Our Ref: CC180099

**DA/161/2024 - Lakes Ridge Development at Lake Munmorah
Response to Council DA Assessment Report - Sewer**

Summary of Council's Comments/Concerns

Figure 1: Sewer Plan

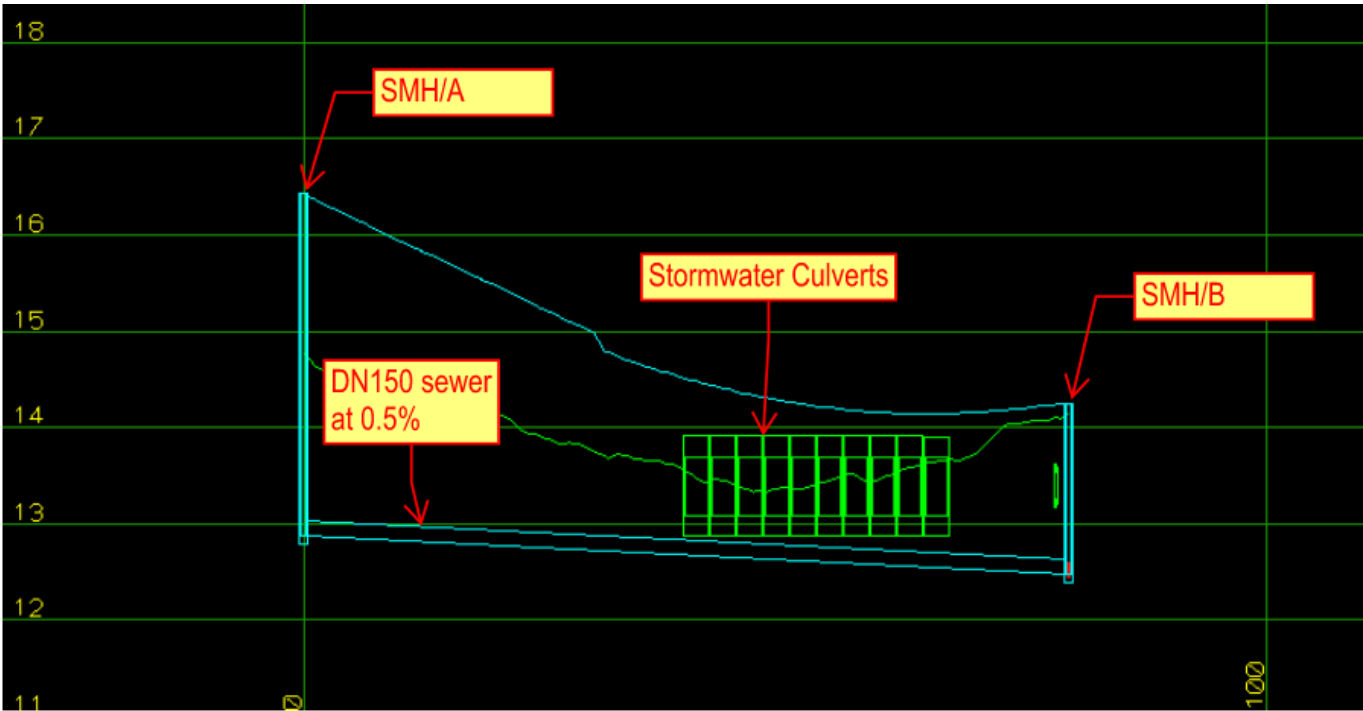
The proposed development includes the construction of a sewer main connection to the existing sewer system adjacent to 24 Kemira road across the northern boundary of the Council reserve 6W Kemira Road which is works within the mapped wetland. The aerial photograph below depicts the extent of the mapped wetland and the location of the sewer.

The proposed sewer works are considered to be designated development. The development application does not address the presence of designated development and has not been lodged as designated development with the appropriate supporting documents under Section 4.12(8) of the Act. And consent can not be granted to the proposed sewer works.

- c. Proposed sewer to connect to new SMH within the proposed northern road reserve.
- d. New SMH approximately 15m downstream of existing SMH BM/13.
- e. All works within the approved BDAR footprint for the project.

A review of Council supplied work-as-executed (WAE) data confirmed that the sewer invert levels at the proposed SMH location, downstream of existing SMH BM/13, are suitable to accept discharge from the proposed sewer that passes under the road box culvert set.

The preliminary arrangement of the proposed sewer is presented below and is subject to further design development as part of the next stage of the design.
